TRANS/WP.29/695

DRAFT SUPPLEMENT 1 TO THE 02 SERIES OF AMENDMENTS
TO REGULATION No. 26

(External projections)

Figure 1 "

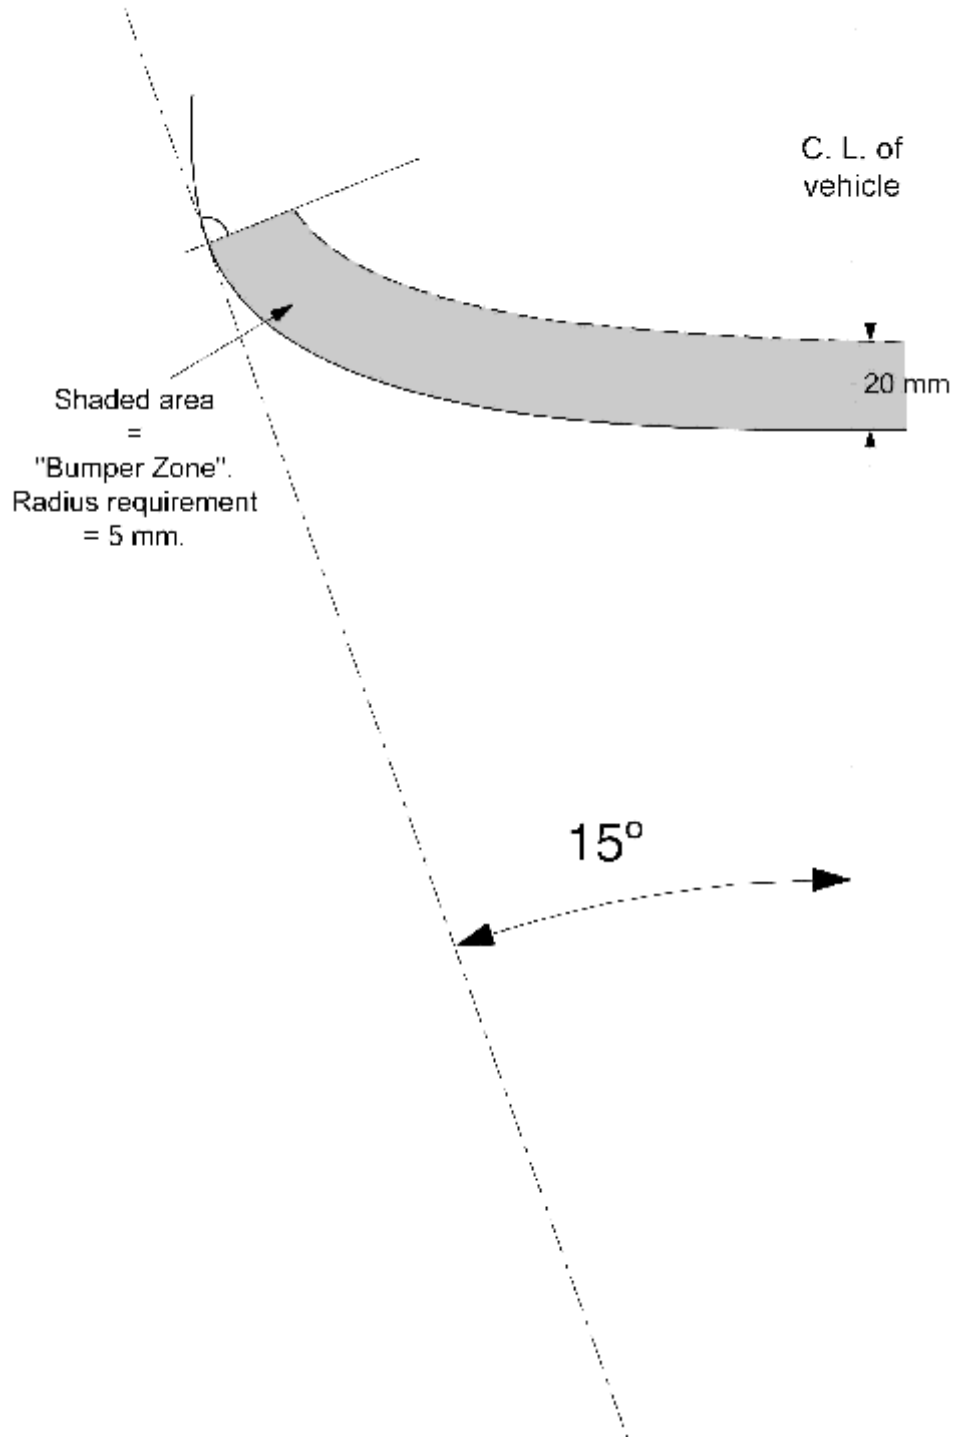
Paragraph 6.5.2., amend to read (including a new figure 1):

"6.5.2. If the line of the bumper which corresponds to the outline contour of the car vertical projection is on a rigid surface, that surface shall have a minimum radius of curvature of 5 mm at all its points lying from the contour line to 20 mm inward, and a minimum radius of curvature of 2.5 mm in all other cases. This provision applies to that part of the zone lying from the contour line to 20 mm inward which is situated between and in front (or rear in case of the rear bumper) of tangential points with the contour line of two vertical planes each forming with the longitudinal plane of symmetry of the vehicle an angle of 15° (see fig. 1).
